ADDENDUM NO. 2

For: Humble Independent School District
AMS / HMS Additions & Renovations
10203 Birchridge Drive
Humble, TX 77338

PREPARED BY: PFLUGER ARCHITECTS

PROJECT NO: 24-042

C4.0
DEMOLITION PLAN

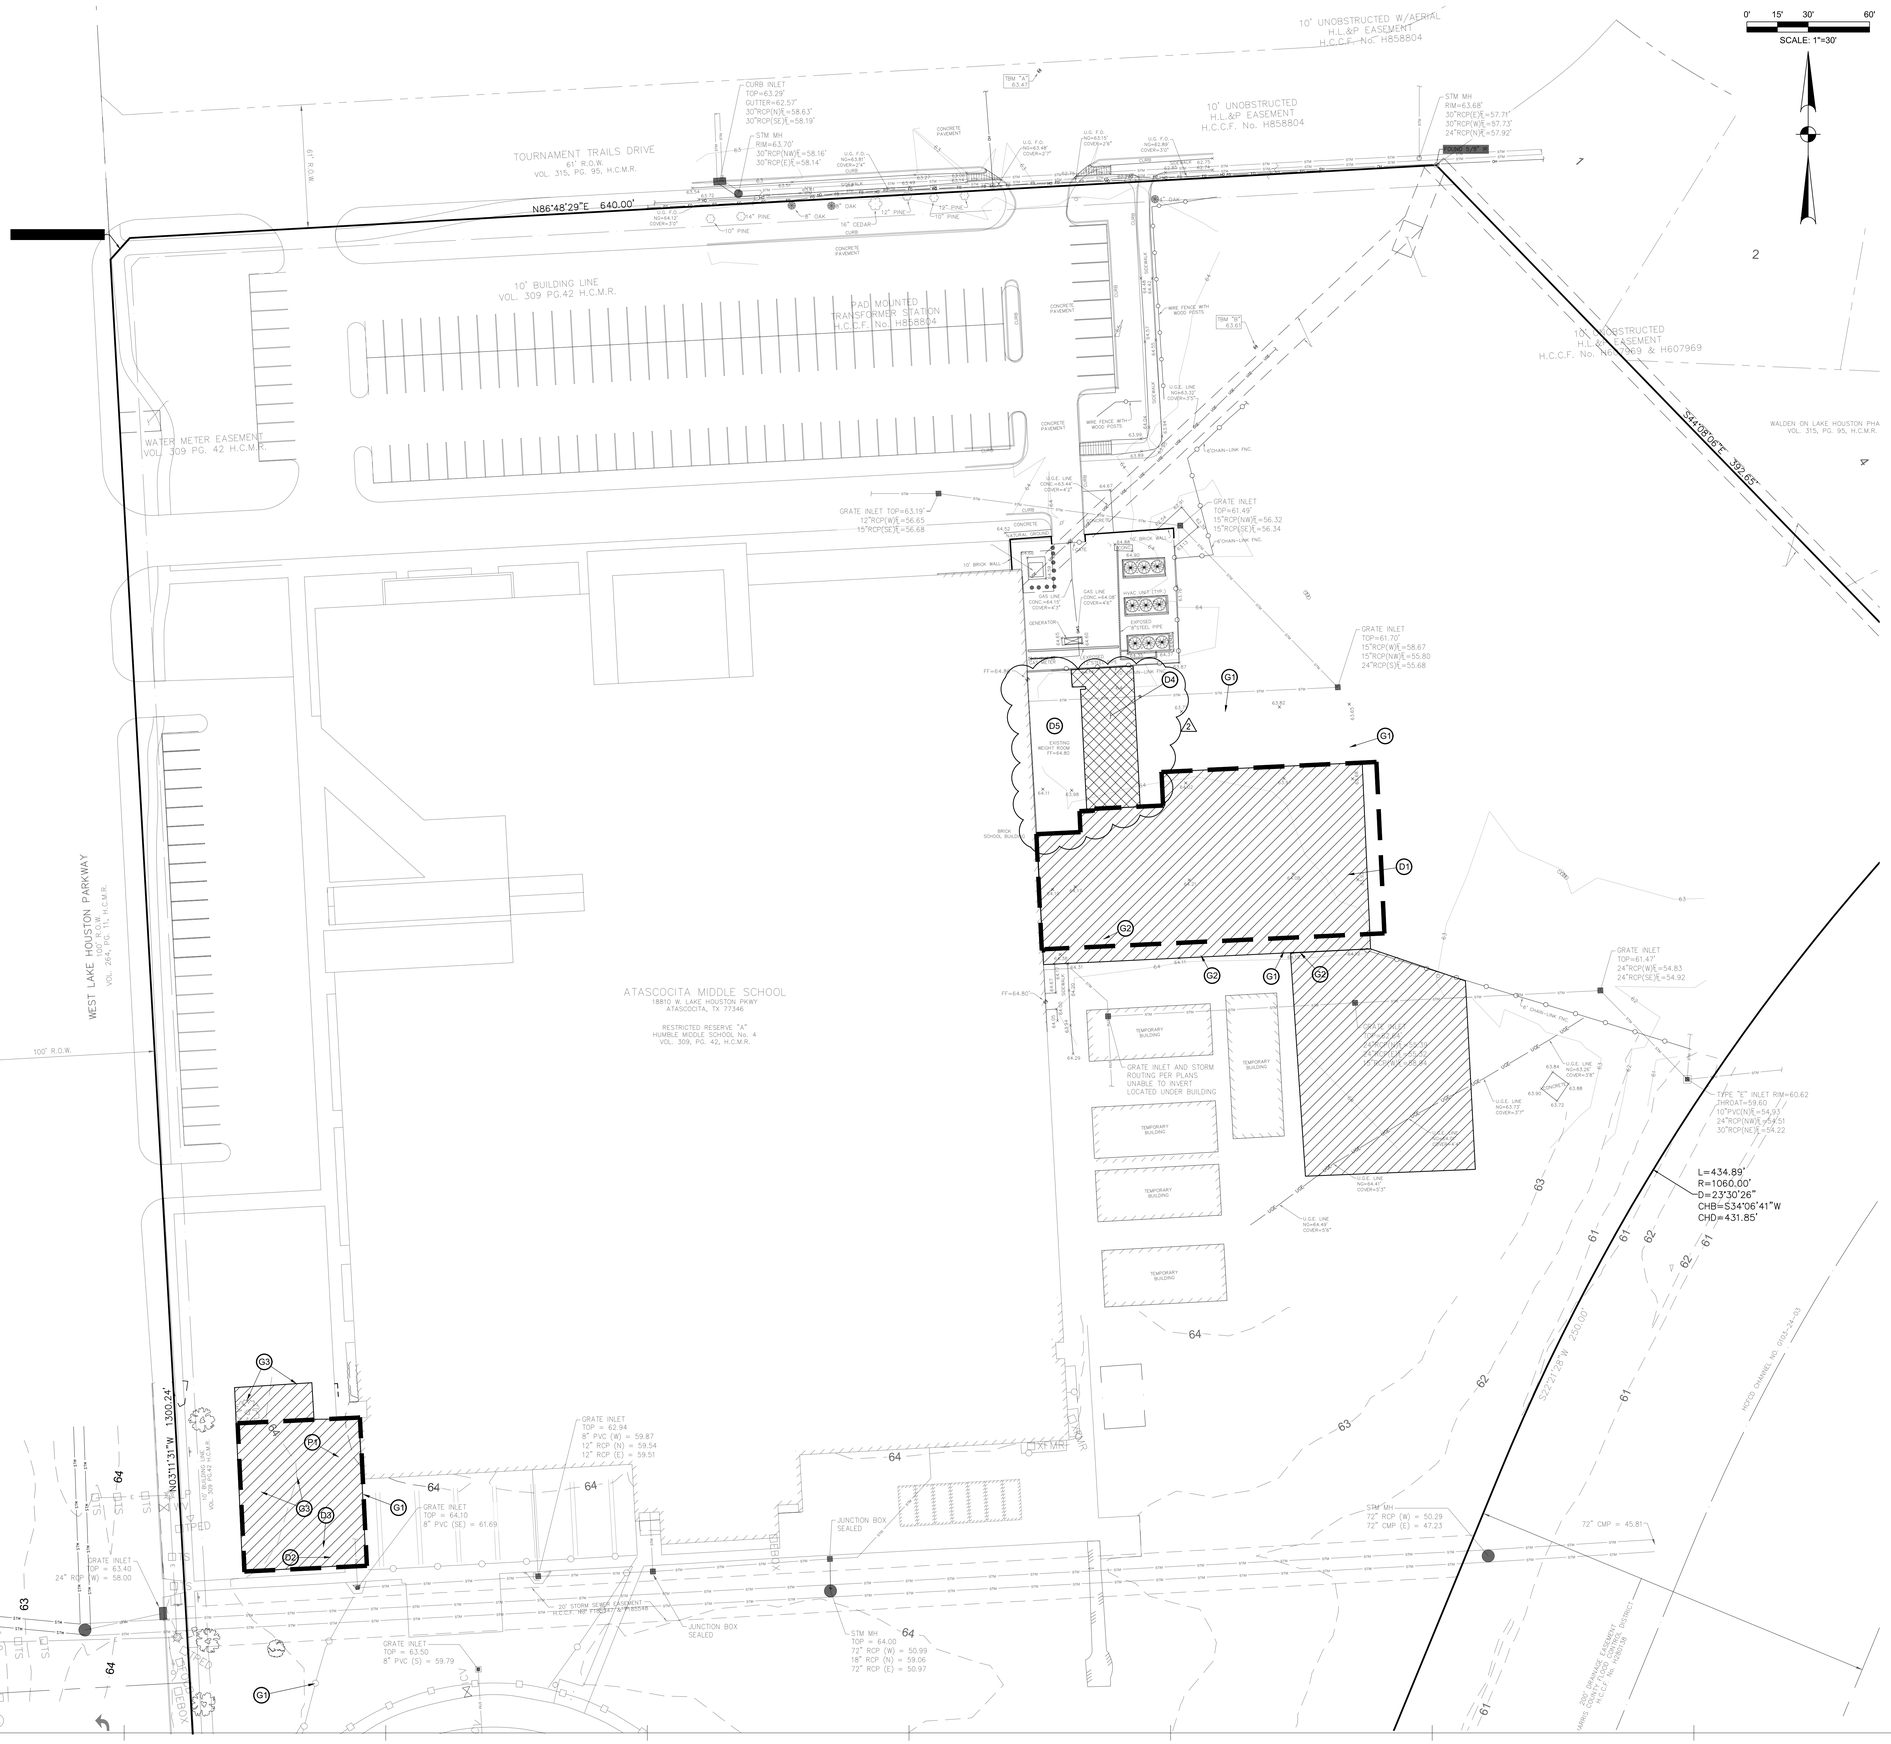
ITEM	SHEET	DESCRIPTION
HUMBLE MIDDLE SCHOOL		
D2-1	C4.00	Revised proposed demo at existing weight room and alternate 4 turf area.
D2-2	C4.00	Revised keynote D4.
D2-3	C4.00	Revised keynote D5.
D2-4	C8.00	Revised proposed storm layout at turf area for alternate 4.
D2-5	C8.00	Added callout for canopy 12” roof drain collector pipe at gym addition.
D2-6	C8.00	Revised keynote D6.
D2-7	C8.00	Added keynote D8.
D2-8	C9.00	Added grading at turf area for alternate 4.
D2-9	C13.00	Added turf detail for alternate 4.
ATASCOCITA MIDDLE SCHOOL		
D2-10	C4.00	Revise demo hatch at existing weight room and alternate 4 turf area.
D2-11	C4.00	Revised keynote D4.
D2-12	C4.00	Revised keynote D5.
D2-13	C8.00	Added proposed storm layout at turf area for alternate 4.
D2-14	C8.00	Added keynote D5.
D2-15	C9.00	Added grading at turf area for alternate 4.
D2-16	C13.00	Added turf detail for alternate 4.

1 2M02.02H **MECHANICAL PLAN - FIRST LEVEL - AMS - SEGMENT 'H'**
1/8" = 1'-0"

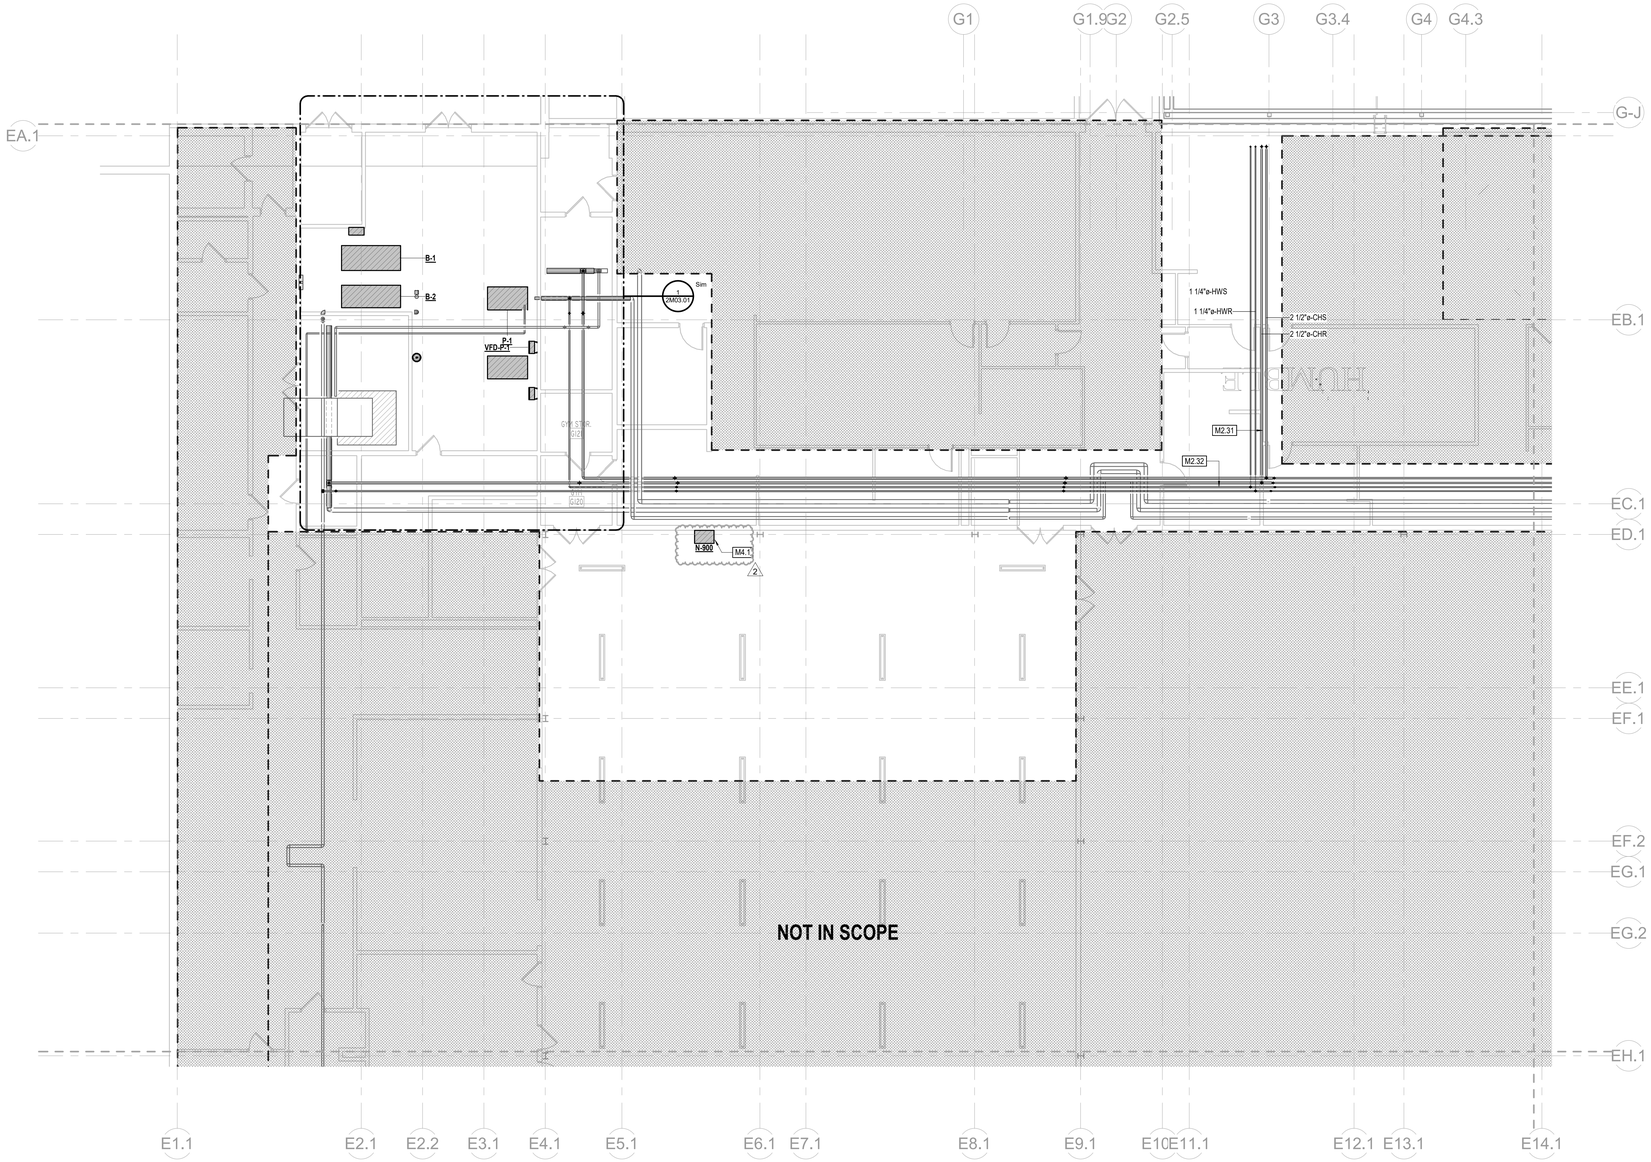
D2-22	2M02.02D	Added Air Purification Unit. Added Keyed note M4.3
D2-23	2M02.02H	Added Air Purification Unit. Added Keyed note M4.3

1 2M02.03 **MECHANICAL ROOF PLAN - AMS**
1" = 20'-0"

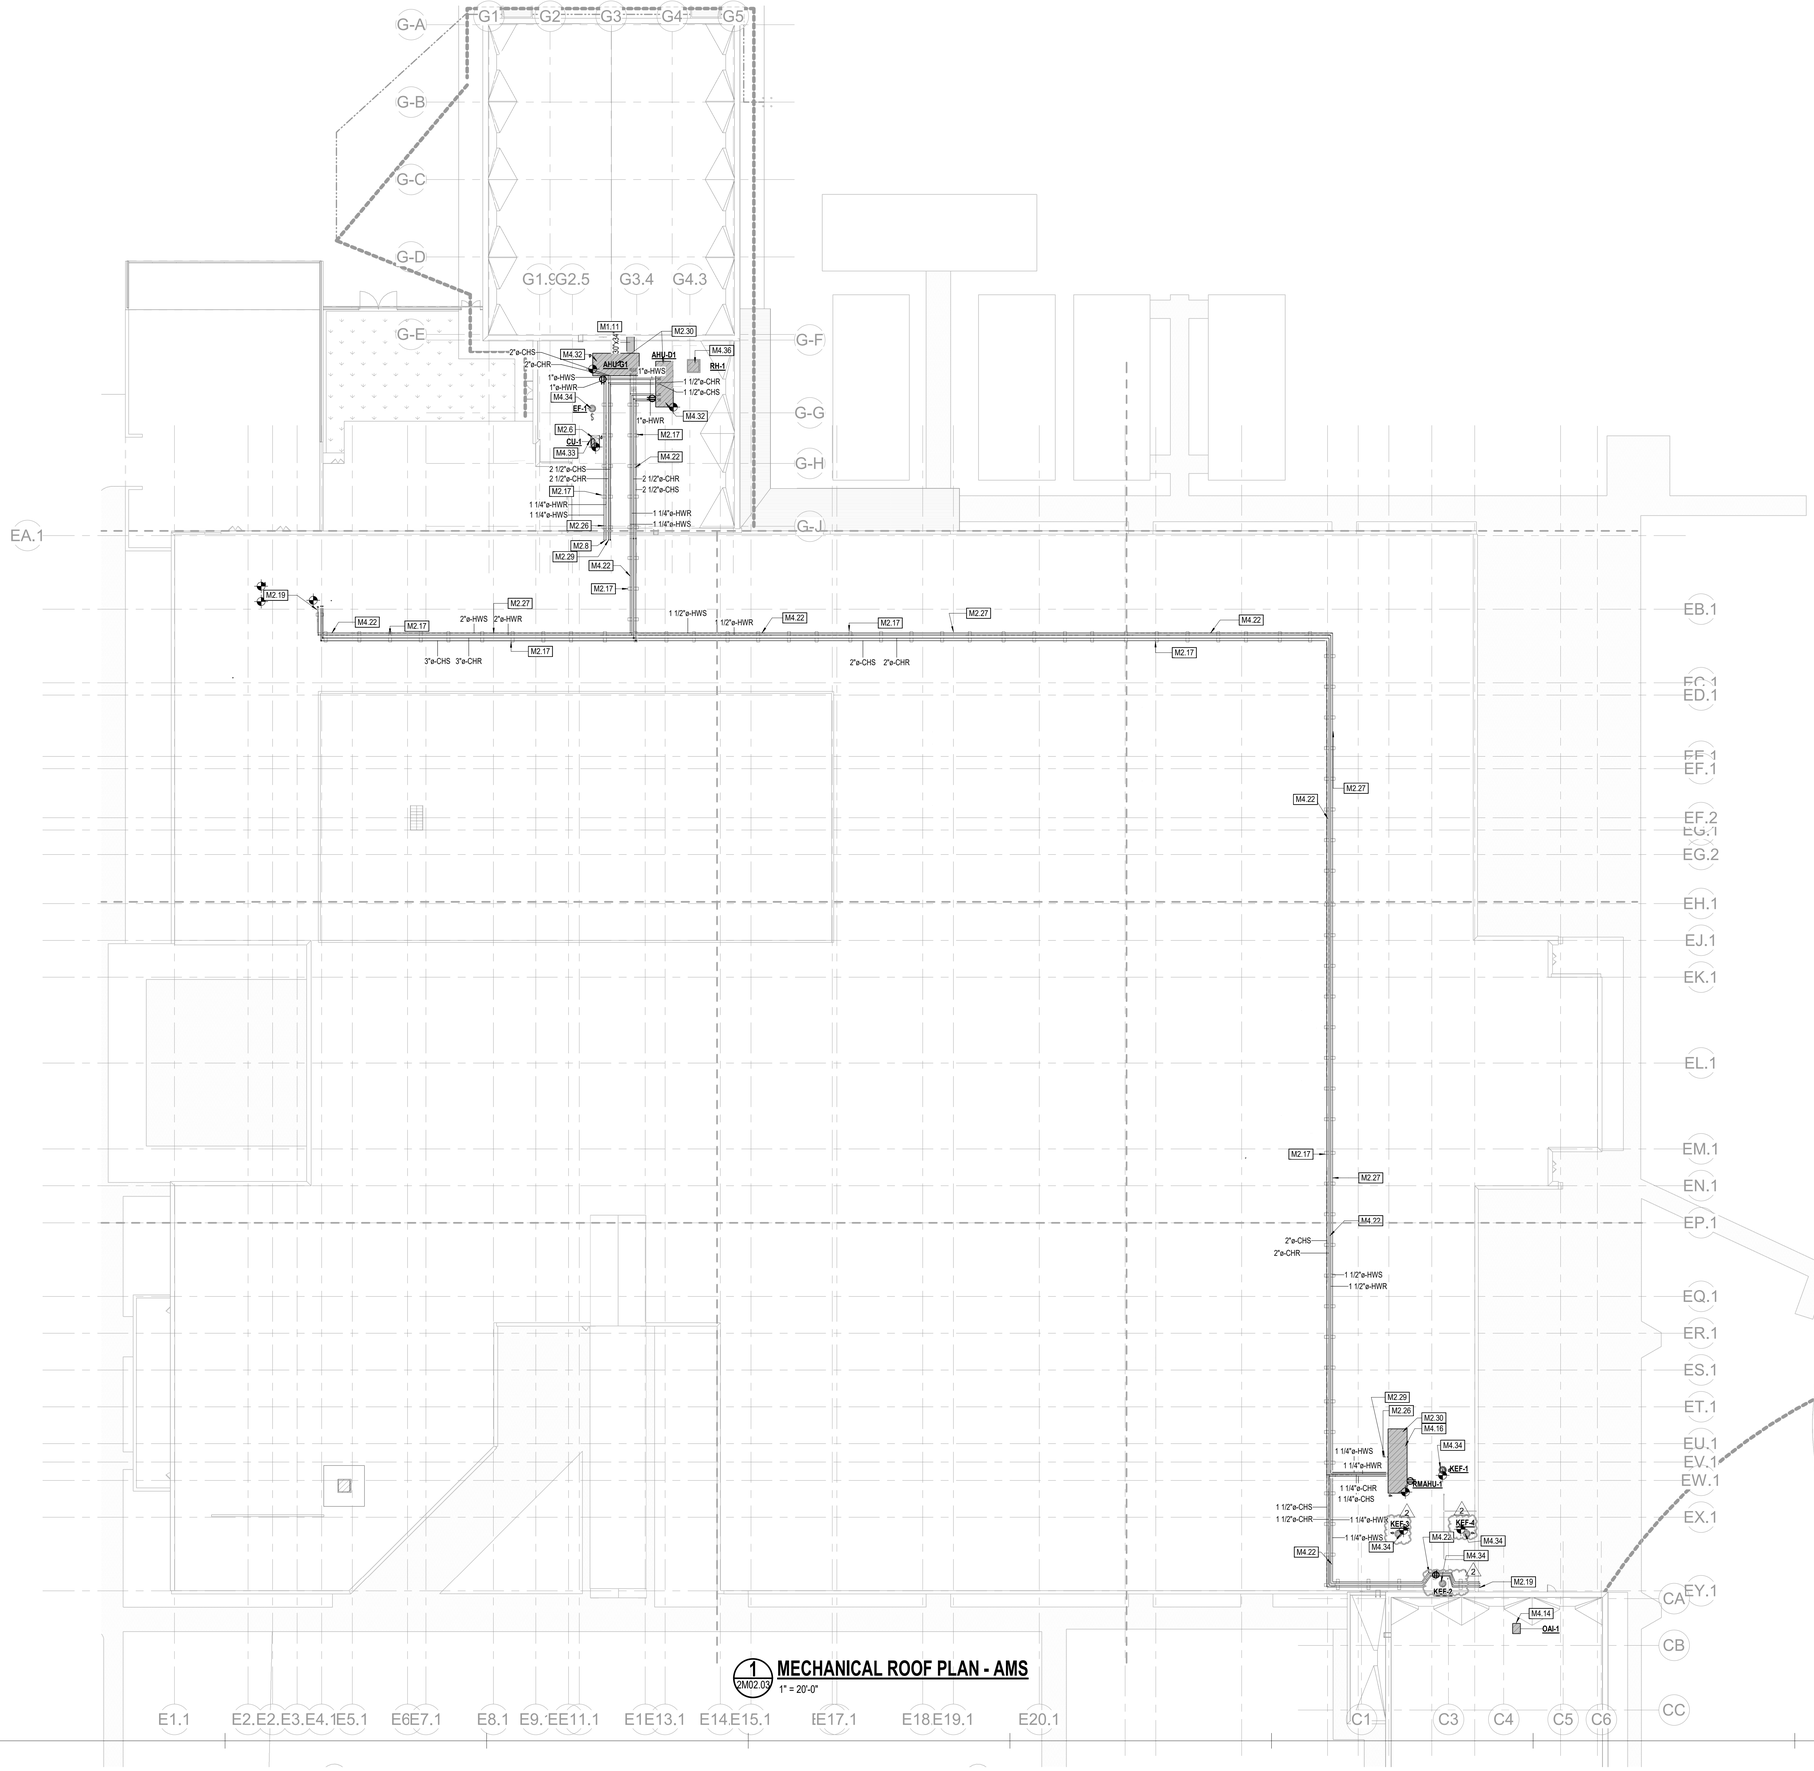
D2-24	2M02.03	Added KEF-3 and KEF-4.
D2-25	2M03.01	Revised drawings to clarify the phasing of VFD-P-10, VFD-P-1, and VFD-P-1-2. Increased HWR piping serving B-2 from 4" Ø to 6" Ø. Added pump to central plant and updated piping to follow flow diagran.
D2-26	2M03.11	Modified exhaust ductwork and rerouted connections so each hood is served by a dedicated fan. Added VFD-KEF-3 and VFD-KEF-4. Modified ductwork connecting to hoods and fans to use radius elbows in lieu of 90-degree elbows. Modified M4.26 to include coordination with food service consultant.
D2-27	2M04.01	Modified Chilled Water - AC - Dedicated Primary / Headered Secondary System Diagram to include tie in of CHS to existing chillers.
D2-28	2M04.02	Added Sequence #3 - Alternate Chiller-Pump Integration. Modified and clarified some items for Sequence #2 and Sequence #1 to match design intent.
D2-29	2M04.04	Added new sheet to include Sequences for (1) Heat Pump Makeup Air - Control Schematic and Sequence of Operations; and (2) Kitchen Fans.
